19 February 2021

A00.03283-L01-v1.0-20210219.docx

### **Arentz Property - Tumut Independent Review - Flooding**

Figure L2 – Provisional Hydraulic Hazard Categories of the NSW Floodplain Development Manual.

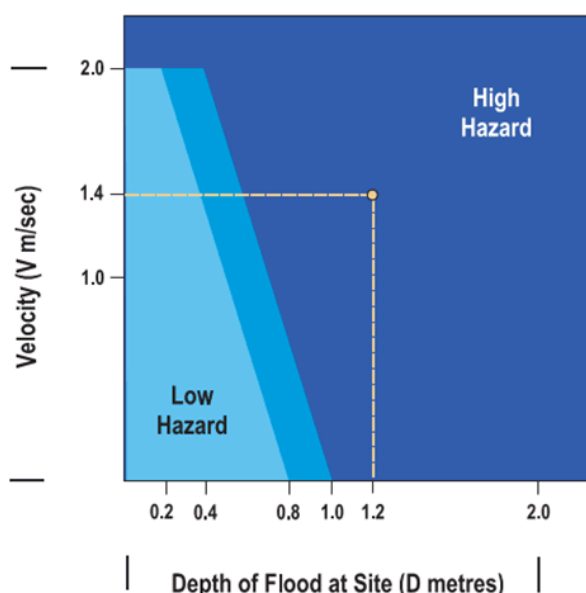
Flood Hazard at the specific building site has been assessed in accordance with Figure L2 – Provisional Hydraulic Hazard Categories of the NSW Floodplain Development Manual (reproduced below)

The estimated 100 year flood level is at RL 264.0. The depth of flood waters at the building site with a floor level of 263.0m would be approximately 1.0m. The 1984 Flood Study provides an estimate of average flood velocities of 0.9m/s across the floodplain. Based on these depths and velocities the site would be a **high hazard** area.

However, at the actual building site location on the edge of the floodplain the velocities would likely be significantly less than 0.9m/s, and based on SLR experience would likely be around 0.5m/s at that specific location. If carpark levels are raised by 0.5m in accordance with SLR's recommendations (see below), then the flood hazard would be **low hazard**. (depth 0.5m, velocity 0.5m)

With consideration to the LEP and flood hazard it is recommended that the carpark level be raised by 0.5m.

⇒ **It is recommended that floor levels of the proposal be amended as follows:**

- **carpark raised from RL 263.0 to RL263.5**
